CITY PLAN COMMISSION STAFF REPORT

Project Name
Emmanuel Science and Technology Center

Request
CD-CPC-2025-00037
Area Plan Amendment
CD-CPC-2025-00008
Rezoning without Plan
CD-CPC-2025-00004
Development Plan – Nonresidential

Development Plan Application Resubmittal 001
 Kansas City, MO: City Plan Commission
 02.14.2025

J1 Building-Mounted Wall Sign
 1/2" = 1'-0"
 0 6" 1" 2"

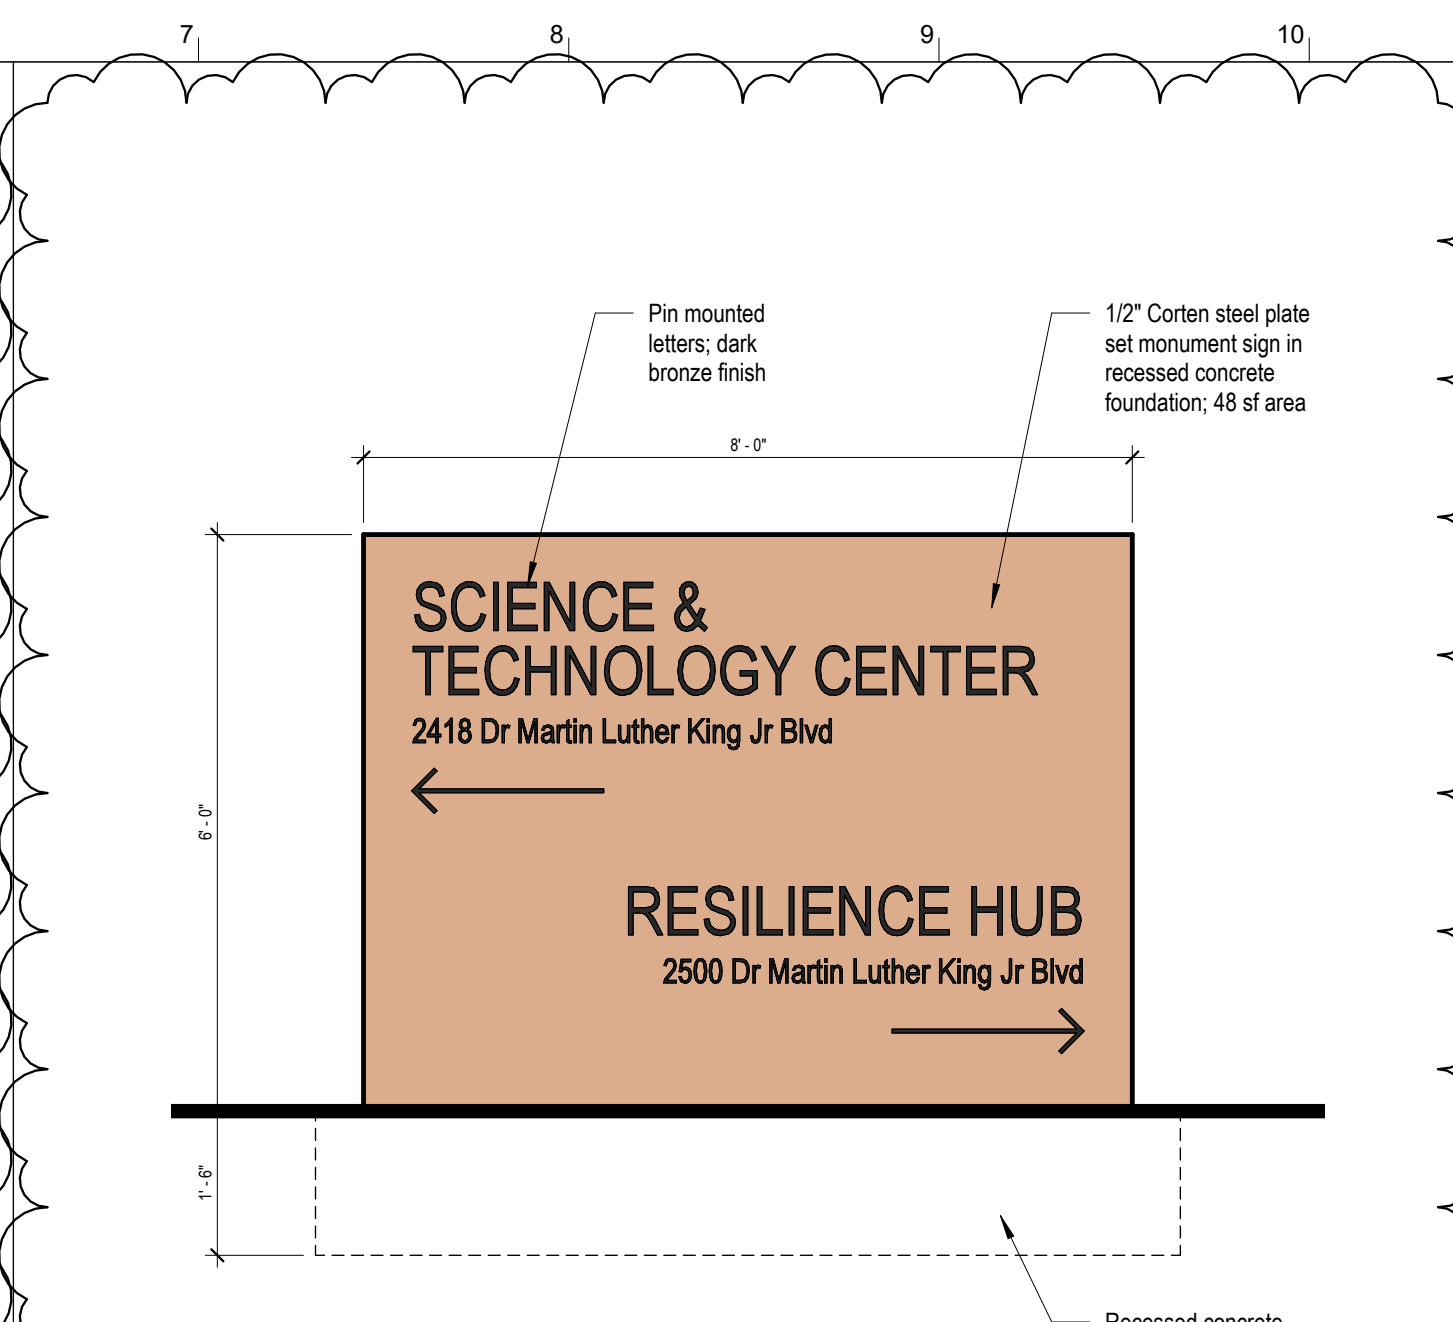
Variance 5 – A variance to 88-445-07 – A wall sign shall not exceed 50 square feet.

6. All signage shall conform to 88-445 and shall require a sign permit prior to installation.
7. That prior to recording the Final Plat the developer shall upload and secure approval of a Street Tree Planting Plan from the City Forester.

Building Elevations

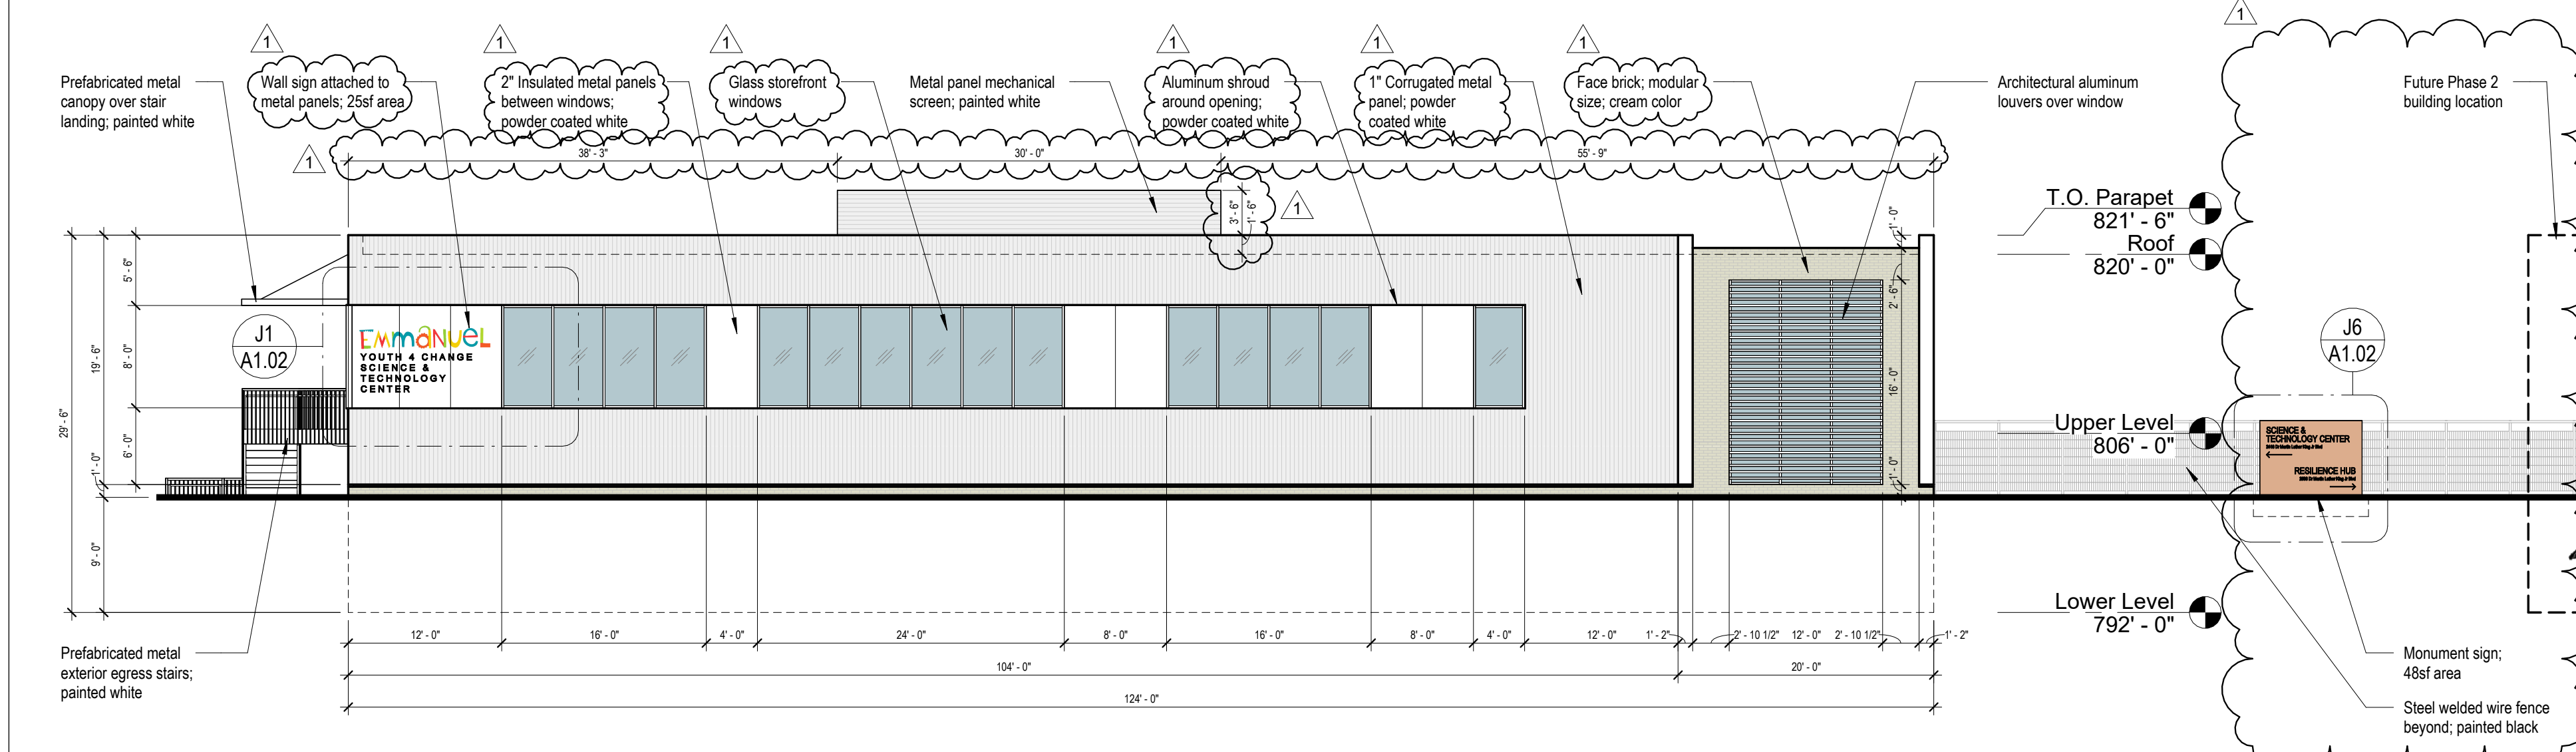
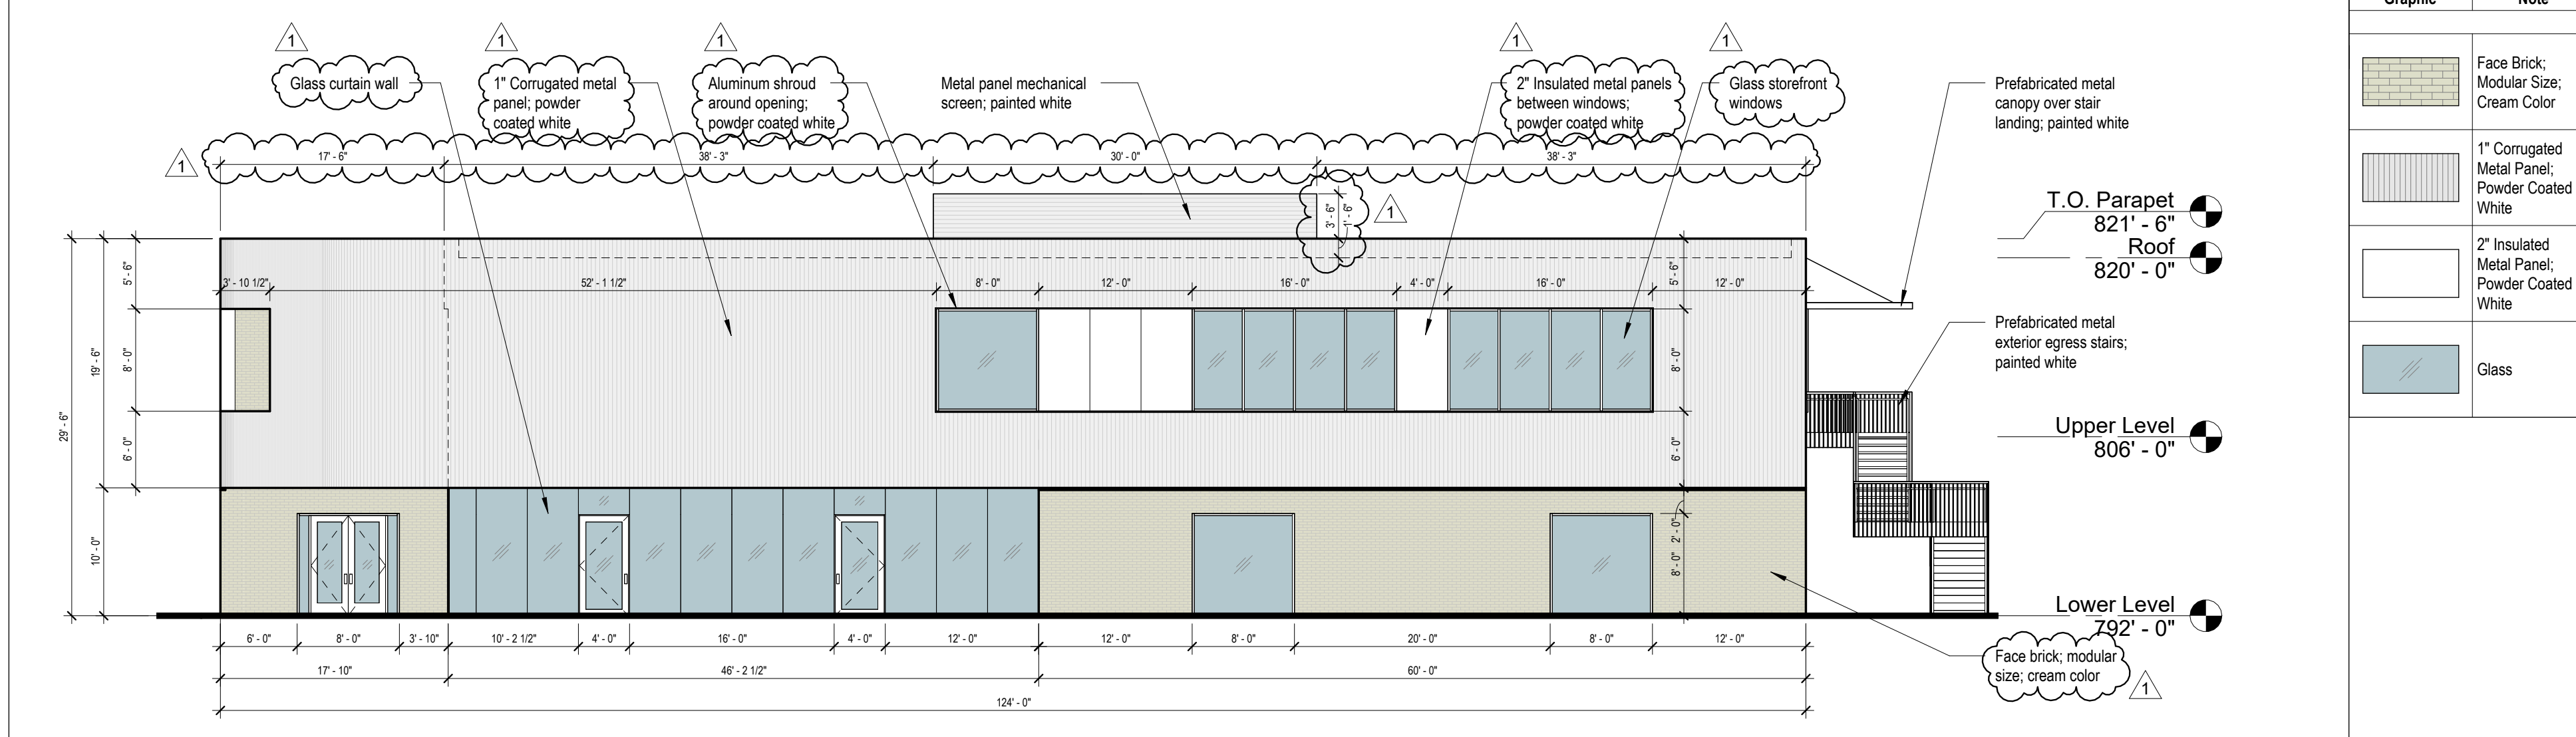
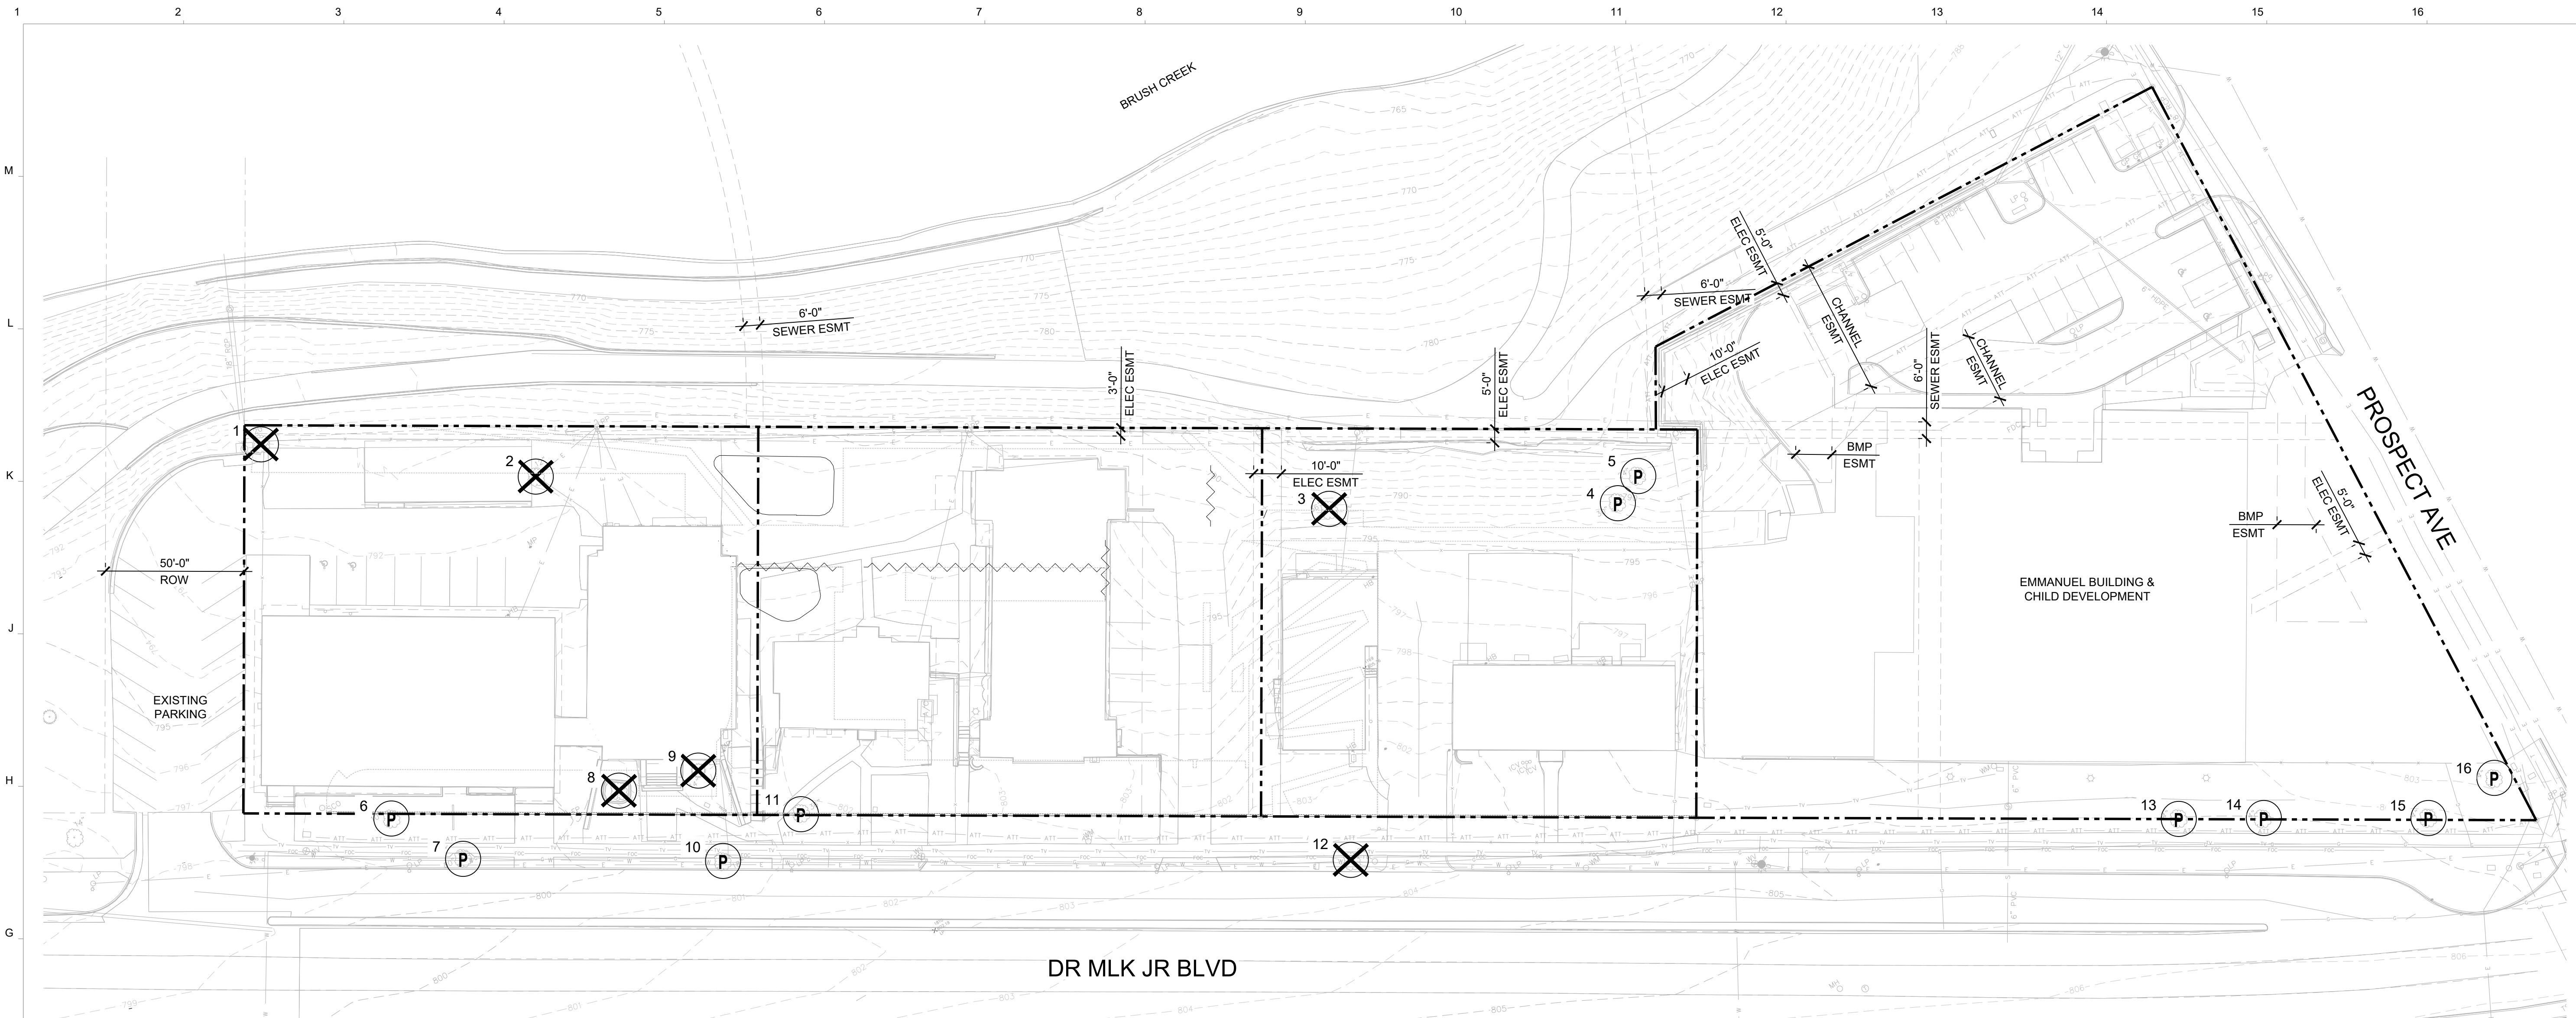
Variance 3 – A variance to 88-323-02-E (6) – If adjacent to and within 150 feet of a parkway, structures shall provide a minimum of 33% transparency on the ground level façade facing the parkway.

4. That all lots and structures along the parkway shall meet the parkway standards (88-323).
5. That the developer receives approval of the required variances from the Board of Zoning Adjustment or revise plans to show compliance with the Zoning and Development Code.
